Service Letter No. 459

SUBJECT: Mixture Control Cable Shield

MODELS AFFECTED: PA-24-400, Serial Nos. 26-1 to 26-124 inclusive

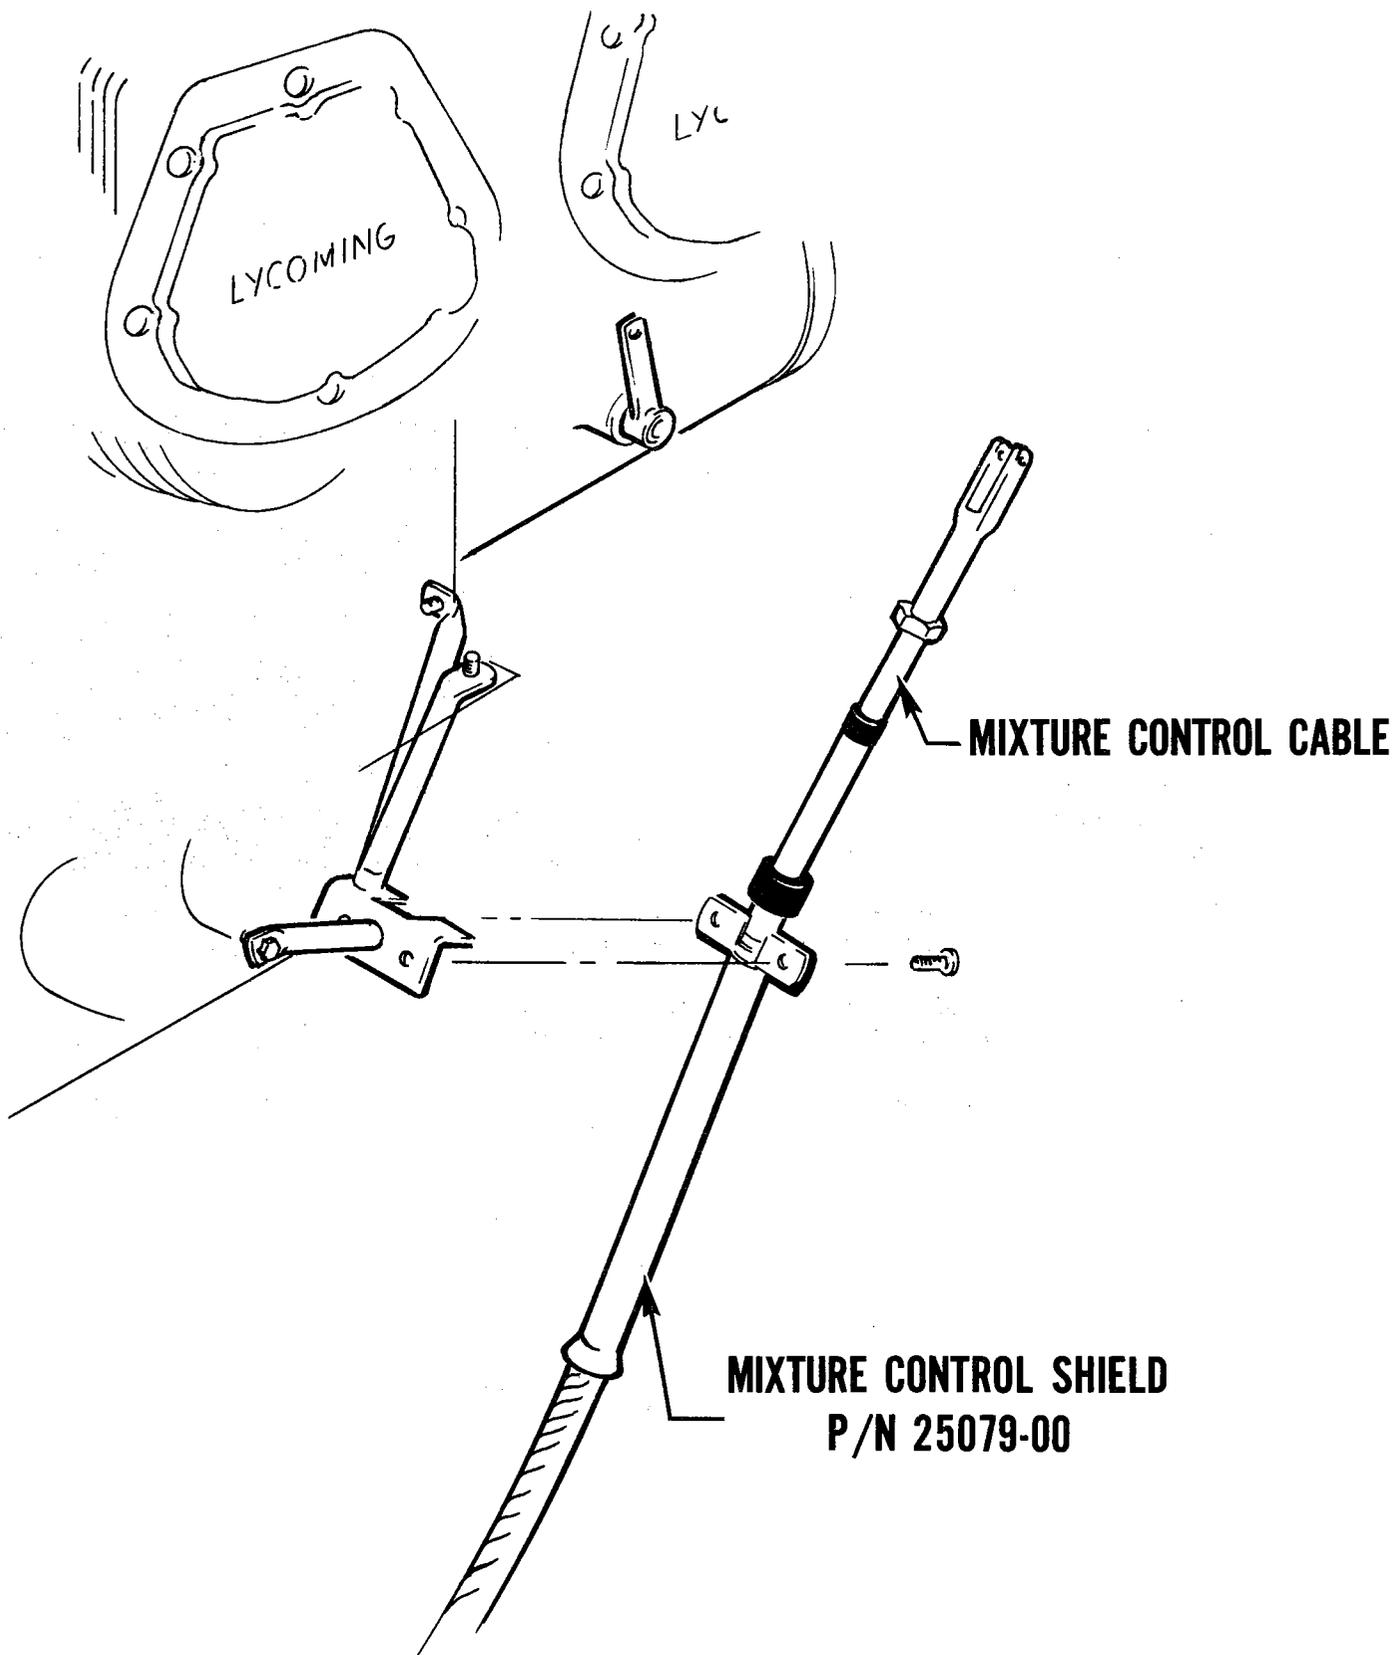
Several reports have been received of binding or broken mixture control cables on the PA-24-400. This binding or breaking has generally occurred in the engine compartment at the fuel injection servo end of the control.

A shield has been added in the engine compartment to protect the mixture control. (See sketch on the reverse side of this letter.)

This shield should be ordered under part number 25079-00. When this shield is installed discard clamp presently used.

The mixture control should be inspected for condition and proper operation before installation of shield 25079-00.
